FINITE ELEMENT SOLUTION OF SAINT-VENANT EQUATIONS^b

Discussion by Danny L. Fread,³ M. ASCE

FIG. 7.—Typical Single-Value and Loop Rating Curves

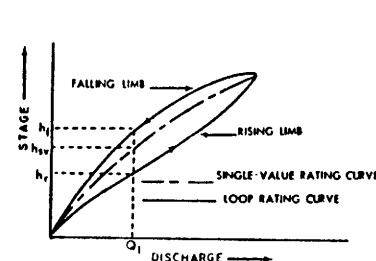
more accurate than the finite difference method for this particular example. This is a questionable conclusion, since the authors have use a downstream boundary condition in the finite element solution different from that used in the finite difference solution. The authors used a single-value rating curve based on Manning's equation, with the channel bottom slope used as the energy slope. Their solution, particularly at the downstream boundary, can be different from that obtained using a loop rating curve based on the Manning equation with a variable energy slope to account for unsteady nonuniform flow as used in the finite difference solution. This is indicated in the authors' Fig. 5, where,

on the rising limb of the stage hydrograph, the finite element solution using 12-hr time steps exceeds that of the finite difference solution using 12-hr time steps and, on the falling limb, the relationship is reversed. This relationship is identical to that which would result when using the two different boundary conditions, as indicated in Fig. 7 by the relative magnitudes of the stages, h_1 , h_2 , and h_3 , associated with the rising limb (loop rating), falling limb (loop rating), and single-value rating, respectively.

FIG. 8.—Effect of Channel Slope and Downstream Boundary Rating Curve on Computed Downstream Hydrographs

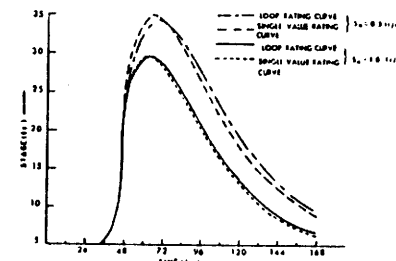
The difference in the hydrographs due to the type of rating curve used at the downstream boundary is sensitive to the channel bottom slope and the

rate of change of the hydrograph. For the particular hydrograph examined by the authors, which has a time to peak of 48 hr and a 0.5-hr time step, the root mean square deviation between the two hydrographs (see Fig. 8) is 0.358 ft (0.109 m) when the channel bottom slope, S_b , is 1.0 ft/mile (0.0001894 ft/ft); however, when the bottom slope is reduced to 0.5 ft/mile (0.0000947 ft/ft), the root mean square deviation increases to 1.002 ft (0.306 m). A more complete presentation of the effects of slope and rate of change of flow on hydrographs determined from single-value and loop rating curves is given by the writer (22, pp. 30-35).

FIG. 9.—Effect of Time Step on Root Mean Square Deviation of Downstream Hydrographs for Loop and Single-Value Rating Curves (Loop Rating Curve with 0.5-hr Time Steps Used as Standard for Comparison)

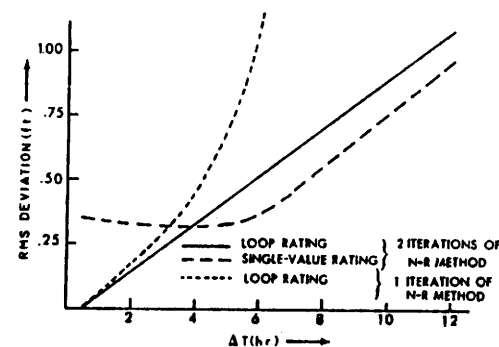
The computed downstream hydrograph is sensitive to the size of time step. Using the loop rating curve with 0.5-hr time step as the standard for comparison, the root mean square deviations of other downstream hydrographs with different size time steps are shown in Fig. 9. The root mean square deviation associated with the single-value rating curve is less than that of the loop rating curve for time steps in excess of 4 hr. The root mean square values for 12-hr time steps are 1.094 ft (0.334 m) and 0.971 ft (0.296 m) for the loop and single-value rating curves, respectively. Thus, by using the single-value rating curve with 12-hr time steps, as the authors have done, the computed downstream hydrograph generated by the four-point finite difference scheme deviates less from the standard hydrograph than that computed with 12-hr time steps and a loop rating curve. This indicates a compensating effect of the deviations arising from the use of a single-value rating rather than a loop rating boundary condition and the deviations due to numerical truncation errors associated with the time step size. The compensating effect resulted in, at least a portion of, the apparent increase in accuracy, which the authors observed; therefore, it is questionable if the "case 2" example illustrates the superior accuracy of the finite element method as concluded by the authors.

The authors mention that instability was encountered when only the predictor part of the scheme was used. The writer also observed this when the Newton-Raphson method was applied only once each time step. However, when the time step was reduced to 6 hr, the solution became stable, although the root mean square value was twice (see Fig. 9) that obtained when the Newton-Raphson
